PROJECT:
P500 House Type 2

DESCRIPTION:
House Type 2 - Proposed Plans 00

PURPOSE OF ISSUE:
Planning

JOB NO: STATUS CODE: DRAWING NO: REV
3788 S2 155 C

House Type 2 - 2BH 83m² Ground Floor Plan
1 : 50

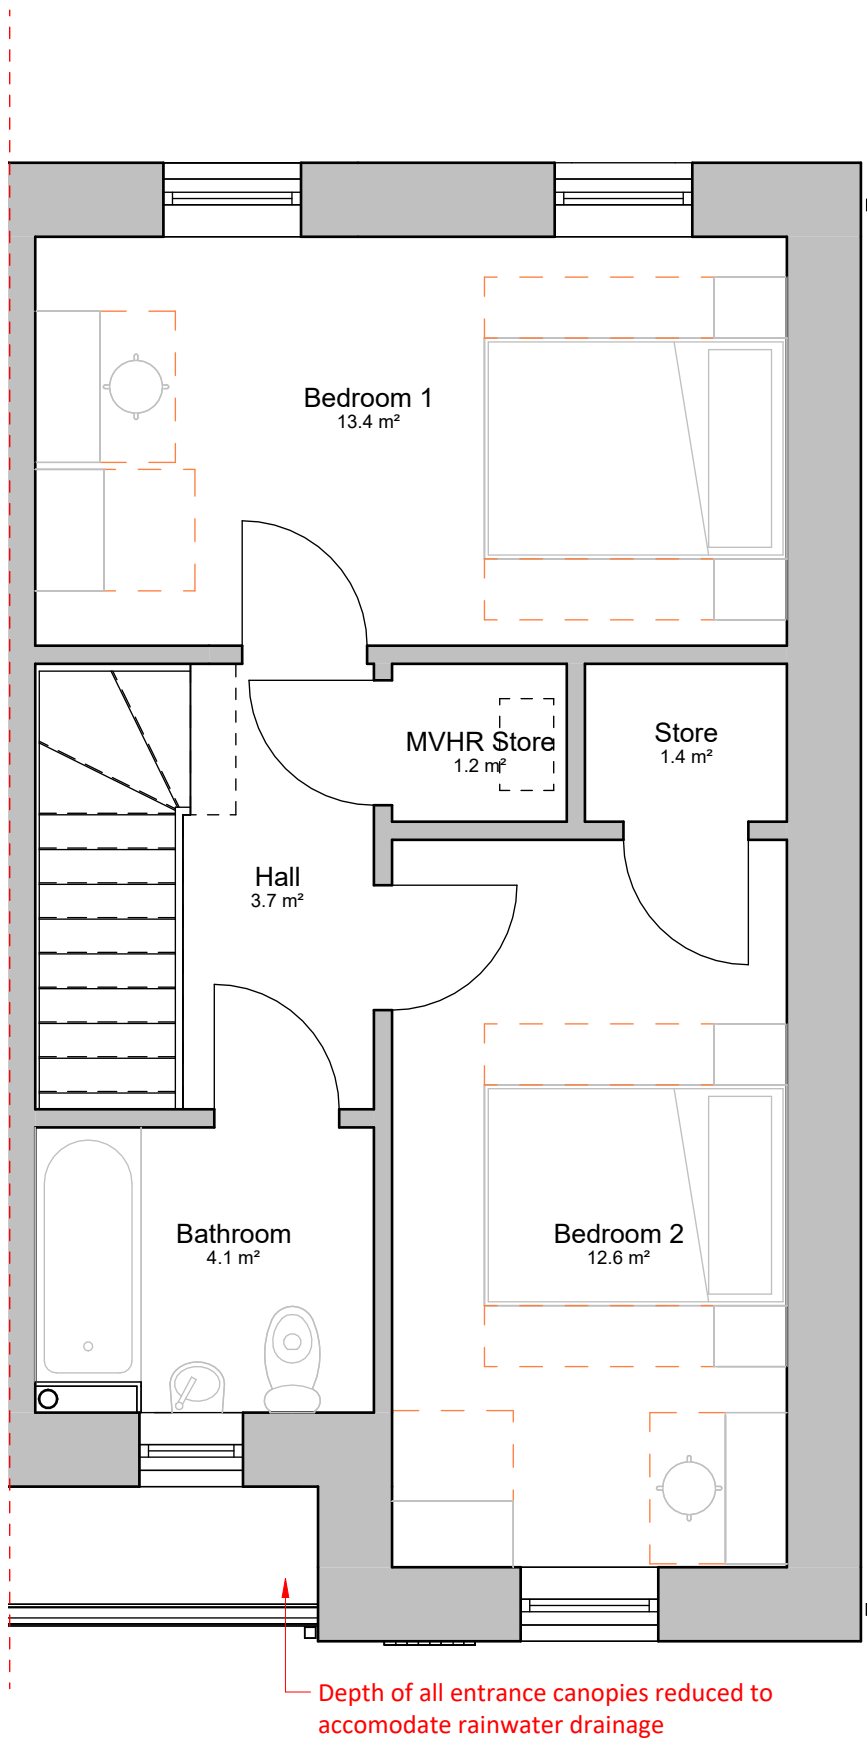
*Internal layouts updated to accommodate cylinder store.
1no. meter box to front of each unit removed in accordance with proposed installation of ASHP and MHVP system
